GROUP ENG	MODEL 2018MY Stinger (CK) 2.0T
	NUMBER 191	DATE November 2018
TECHNICAL SERVICE BULLETIN		
SUBJECT: SERVICE ACTION: 2.0T ECU REPLACEMENT FOR DTC P053F AND/OR P0087 (SA352)

SERVICE ACTION: 2.0T ECU REPLACEMENT FOR DTC P053F AND/OR P0087 (SA352)

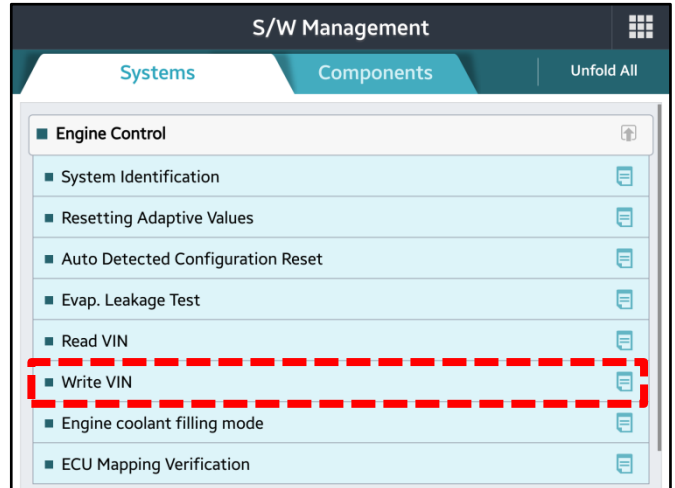
This bulletin provides the procedure to replace the Electronic Control Unit (ECU) on some 2018MY Stinger (CK) 2.0T vehicles, produced from September 29, 2017 through March 27, 2018, which may exhibit engine hesitation and/or a Malfunction Indicator Light (MIL) ON with DTCs P053F and/or P0087 as the engine is warming up to operating temperature. Follow the procedure below to replace the ECU. Before conducting the procedure, verify that the vehicle is included in the list of affected VINs.

P053F: Cold Start Fuel Pressure Performance
P0087: Fuel Rail/System Pressure – Too Low

1. Replace the ECU by referring to the “Engine Control/Fuel System → Engine Control System → Engine Control Module (ECM) → Repair procedures” chapter in the applicable Shop Manual on KGIS.

2. Using a KDS, perform VIN writing for the new ECU.
